RE: 5618 Hazeldean Road - Stage 1

Updated Subdivision Conditions and Zoning Amendment

AMENDED DRAFT CONDITIONS

DRAFT ZONING BY-LAW AMENDMENT

DOCUMENT 1

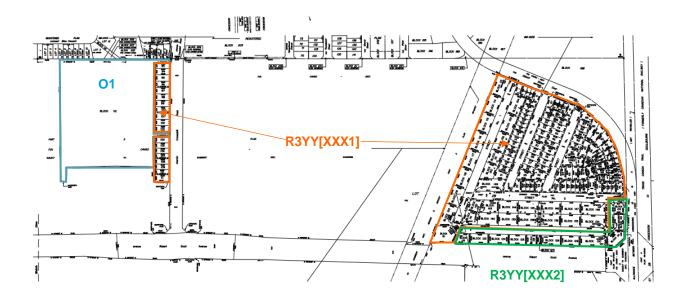
The proposed change to the City of Ottawa Zoning By-law No. 2008-250 for Stage 1 of 5618 Hazeldean:

- 1) Rezone the lands shown in Document 1
- 2) Add a new exception XXX1 to Section 239 Urban Exceptions with provisions similar in effect to the following:
 - a. In Column II, add the text "R3YY[XXX1]"
 - b. In Column V, add the text:
